# **3400 + 3428 Woodroffe Avenue**

Urban Design Brief  
December 2, 2025

The City of Ottawa provided comments in a Feedback Form dated March 11, 2025. Responses to these comments are as follows:

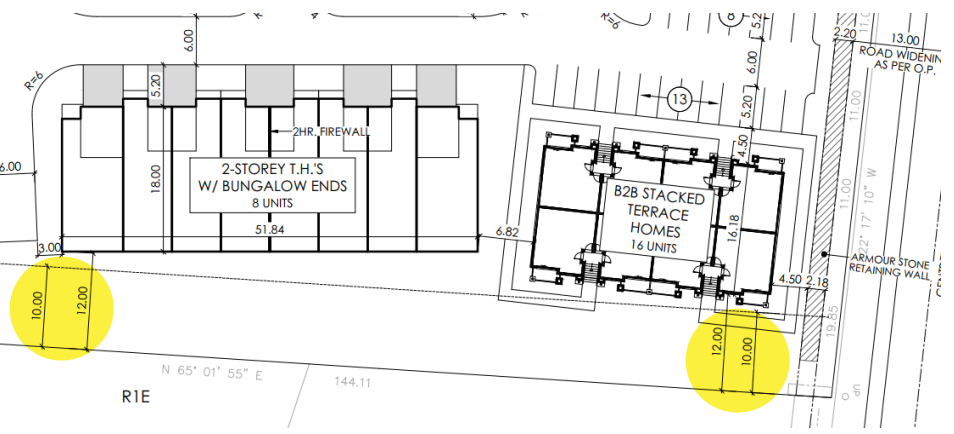
1. Transition to R1E properties, interface with Woodroffe Ave and retention of existing trees on the west and southern property lines are incredibly important and should be discussed in the Design Brief.

A 10-metre has been provided to the west and south of the site where it abuts lands zoned R1E. The buffer is provided to retain the existing trees along the western property edge and soften the transition from the proposed development to existing residential dwellings.

Trees are proposed in the front yard adjacent to Woodroffe Avenue and also dispersed throughout the site. The trees will provide a natural, vegetated buffer between the existing residential dwellings in the Heart’s Desire neighbourhood to the south and west and the existing neighbourhood to the east. They will also shade the proposed sidewalk on the west side of Woodroffe Ave

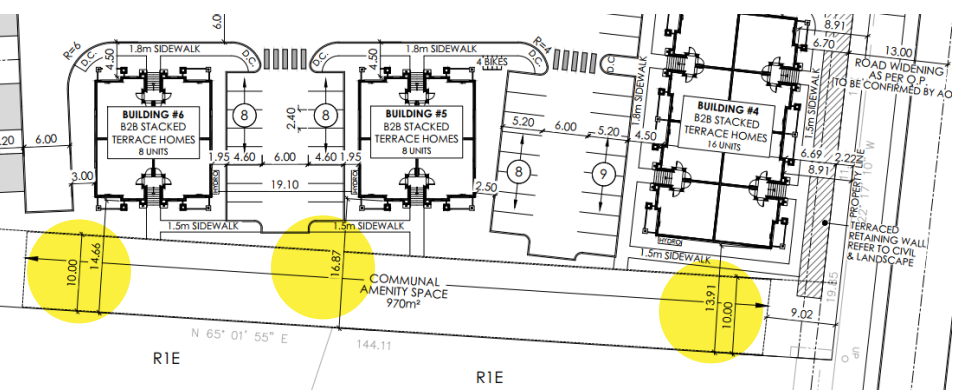
2. The intention for the 10m landscape buffer along the southern property line is to retain trees vs. for it to be private amenity space. Where will private amenity space be provided for these units along the southern property line? An increased setback to provide rear yards for these units, and increased setback to stacks to accommodate the proposed walkway should be provided.

An increased setback between the back-to-back stacked terrace homes and the southern property line has been provided. In the original pre-consultation submission, the walkways extended into the 10-metre buffer and the building itself was set back 12 metres:

In the current concept, the stacked back-to-back terrace home has been rotated so that it faces Woodroffe Avenue and the sidewalk no longer extends into the 10-metre buffer. As well, the two (2) storey townhouses have been replaced with two (2) stacked back-to-back terrace homes, both of which have walkways that do not extend into the buffer. Setbacks to the property line have been increased from 12 metres for the townhouses to 14.66 and 16.87 metres for the stacked back-to-back terrace homes that replaced them, and increased from 12 to 13.91 metres for the southeastern stacked back-to-back terrace home:
